HIROSE ELECTRIC CO., LTD.

Change notice and request for your acknowledgement concerning a change in manufacturing location for the DF20 series male contacts and the addition of a nickel barrier to a portion of the contact.

Single contact

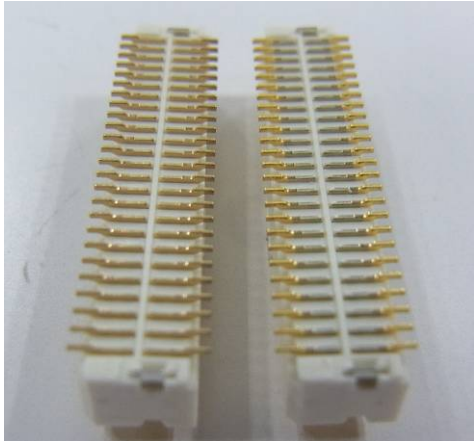
(2) Pursuant to the change in the location of processing, a nickel barrier will be added to a portion of the contact.

In the appearance of the connector, the difference in a portion of the contacts can be observed. However, the electrical and the mechanical performance do not change. We guarantee the same performance as the current products.

The reason is for an improvement in productivity. Also the addition of the nickel barrier has resulted in an improvement of the quality by preventing solder rise.
